What's Changed

The Draft Plan offers new information:

Pedestrian and Bicycle Connections

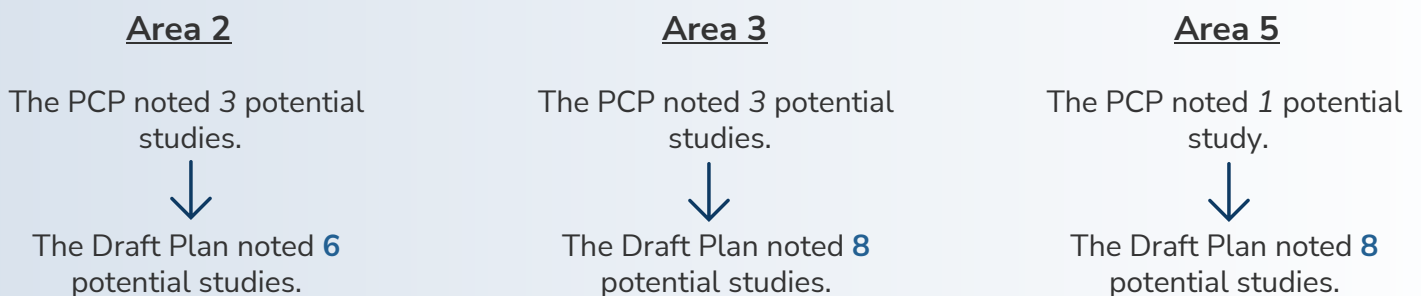
From N. Woodrow Street to Military Rd. on Langston
The PCP proposed a two-way shared use path on one side of road.

From Spout Run Parkway to Veitch St. on Langston
The PCP proposed a two-way shared use path on one side of road.

The Draft Plan proposes **buffered bike lanes on each side of the road.**

The Draft Plan proposes **protected bike lanes on each side of the road.**
